1 ADDENDUM #2

Client:
PEI Department of Transportation & Infrastructure

Project Title:
Montague Consolidated School

Sheet Title:
Tapered Insulation Location

1 NEW ROOF PLAN - PARTIAL
ASK-101 1 : 100

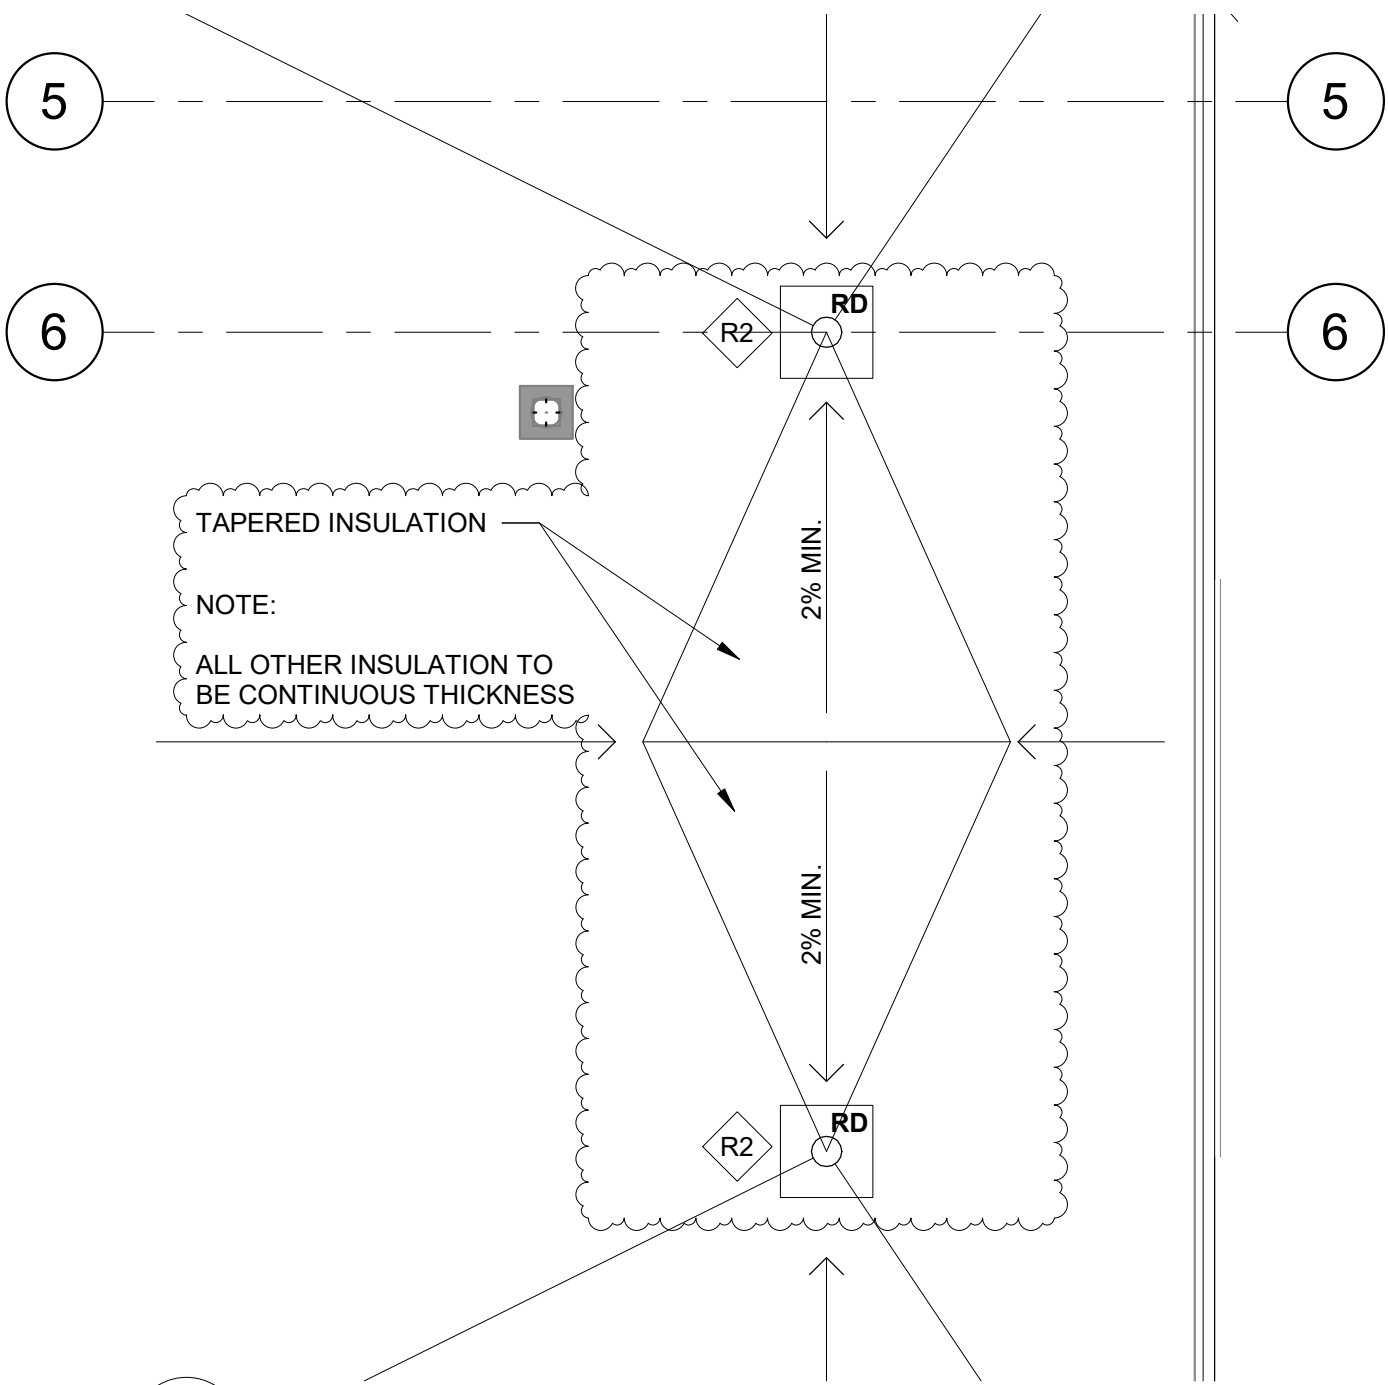
- .7 Reference Section 07 21 13 - Board Insulation:
 - .1 Reference Paragraph 2.1:
 - .1 CLARIFICATION:
The insulation used is to be standard "Sopra-iso" not "Sopra-iso Plus".
 - .2 Reference New Sketch ASK-101:
 - .1 Tapered insulation is to be used as noted in the attached sketch ASK-101. Note, for all other locations the insulation is to be continuous thickness.

TAPERED INSULATION

NOTE:
ALL OTHER INSULATION TO BE CONTINUOUS THICKNESS
